Columbia County Building Permit

## Columbia County Building Permit Application

On the date of June 23, 2006 application 0606-74 and plans for construction of a single family dwelling were reviewed and the following information or alteration to the plans will be required to continue processing this application. If you should have any question please contact the above address, or contact phone number (386) 758-1163 or fax any information to (386) 754-7088.

# Sheet 1

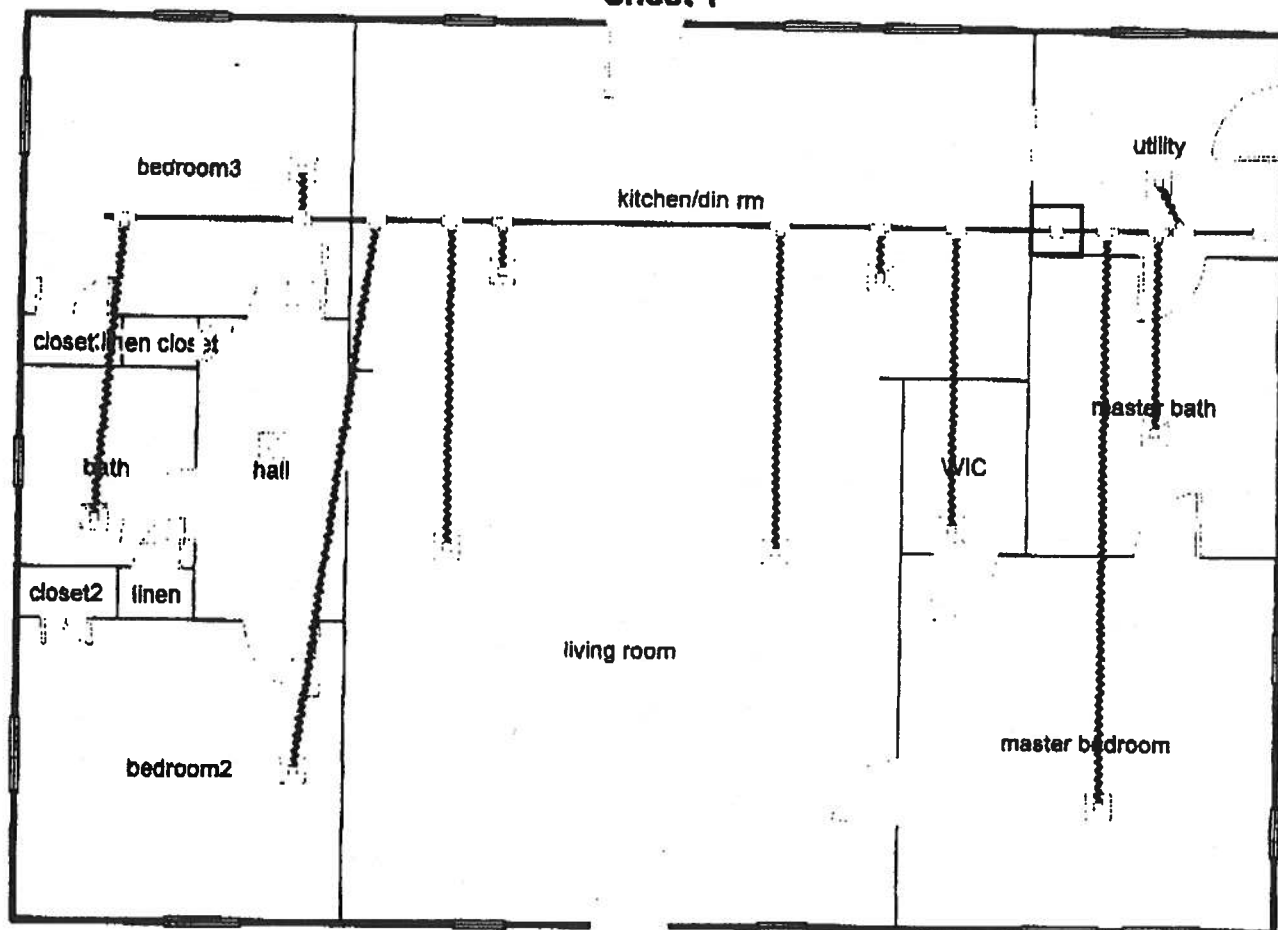
- 1.** Please provide a copy of a signed released site plan from the Columbia County Environmental Health Department which confirms approval of the waste water disposal system.
- 2.** Sheet 1 of the plans structural design criteria, soil bearing value requires that the soils have the bearing of 2000 PSF, therefore please follow the prescribed testing methods to reveal the soil load bearing capacities.

Please have a registered professional conduct subsurface explorations at the project site upon which foundations are to be constructed, a sufficient number (not less than four, one boring on each corner of the building foundation) borings shall be made to a depth of not less than 10 feet (3048 mm) below the level of the foundations to provide assurance of the soundness of the foundation bed and its load-bearing capacity.

- 1.) A signed released site plan from C.C.E.H.D should be complete by 6/28/06. All necessary paper work has been submitted to the Health Department.
- 2.) Please note letter from our P.E., Gregory P. Rivers, concerning soil compaction at 1,000 PSF.
- 3.) We will install 200 AMP electrical panel in the laundry room on the wall over the dryer with 200 AMP Meter base & disconnect outside in same area. All will be wired with (4) four conductors, one of which will be equipment ground.
- 4.) We will install ridge vent the full length of the house w/ vented soffit on eaves.
